SUBJECT: NEW VEHICLE DEMONSTRATION / DELIVERY HOLD

Safety Recall 25SA4 - *Supplement #2*

Certain 2021-2024 Model Year Bronco, 2021-2024 Model Year Bronco Sport, 2020-2022 Model Year Corsair and Escape, 2016-2024 Model Year Explorer, 2019-2020 Model Year Fusion, 2016-2018 Model Year Focus RS, 2022-2024 Model Year Maverick, 2016-2019 Model Year MKC and 2019-2024 Model Year Ranger Vehicles Equipped with a 2.0L or 2.3L Engine and Engine Block Heater System Block Heater Element Replacement

New! REASON FOR THIS SUPPLEMENT

FIGURE 1

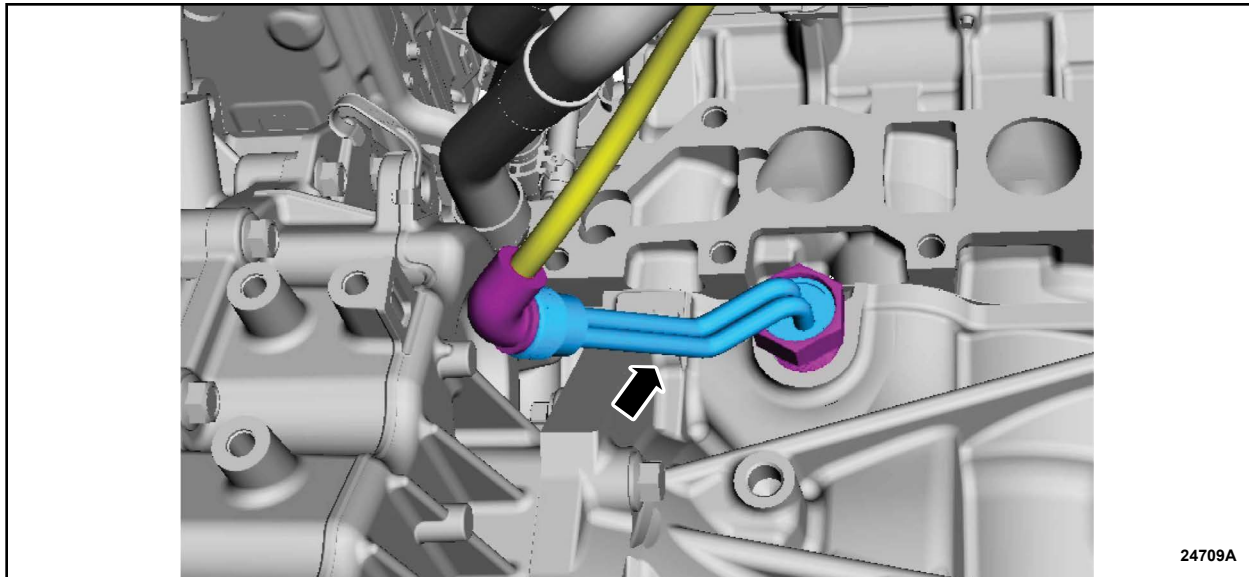
2. Visually inspect the block heater to determine if it is a KS7Z block heater. The block heater is located under the exhaust manifold on the driver side of the engine block. See Figure 1. This style heater has a long extension the power cable plugs into. See Figure 2. Is the block heater a KS7Z block heater?

Yes - This completes the FSA.

No - Contact the Special Service Support Center (SSSC) for further direction.

NOTE: Do not replace the block heater unless explicitly directed by the SSSC.
